10
11 HEARING IN THE MATTER OF
12 CALIFORNIA DEPARTMENT OF
13 WATER RESOURCES AND UNITED
14 STATES BUREAU OF
15 RECLAMATION
16 REQUEST FOR A CHANGE IN POINT
OF DIVERSION FOR CALIFORNIA
WATER FIX

TESTIMONY OF TOM WILLIAMS

Figure 1 Volume Losses Observed on the CTRL Source: ITA 2007

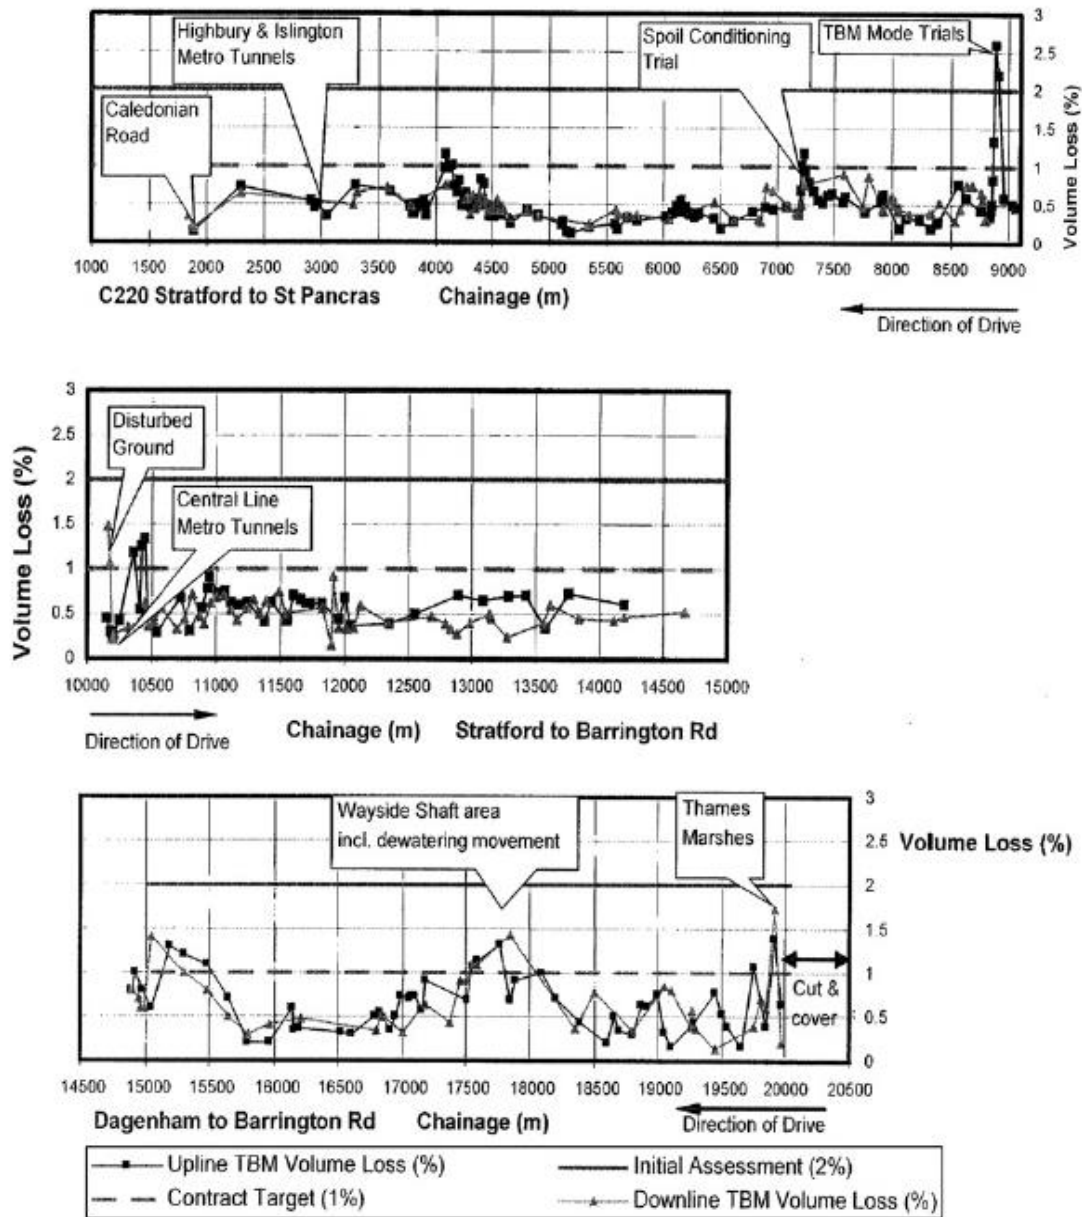
1 on the following page, from that document (Exhibit DDJ-149, p. 12), show the ground volume
2 loss in the tunneling for three London segments of the London Channel Tunnel Rail Link. The
3 mean ground loss was around 0.5% for many segments, but the maximum was over 2.5% in the
4 initial trials. In the Stratford to St Pancras link, once the tunnel ground volume loss exceeded
5 1%, the boring was stopped and the tunnel boring machine was reconfigured for clay soils.

6 The LCRT construction was tightly monitored and had provisions to stop tunneling when
7 ground loss exceeded 1%. The 1% ground volume loss would be an appropriate criteria for
8 maximum allowed ground loss for tunnel boring. Without specification of ground loss criteria,
9 evaluation and alternatives cannot be determined if the criteria are appropriate protection of the
10 surface and other project subsurface structures that are in the tunnel alignment, including water
11 diversion structures.
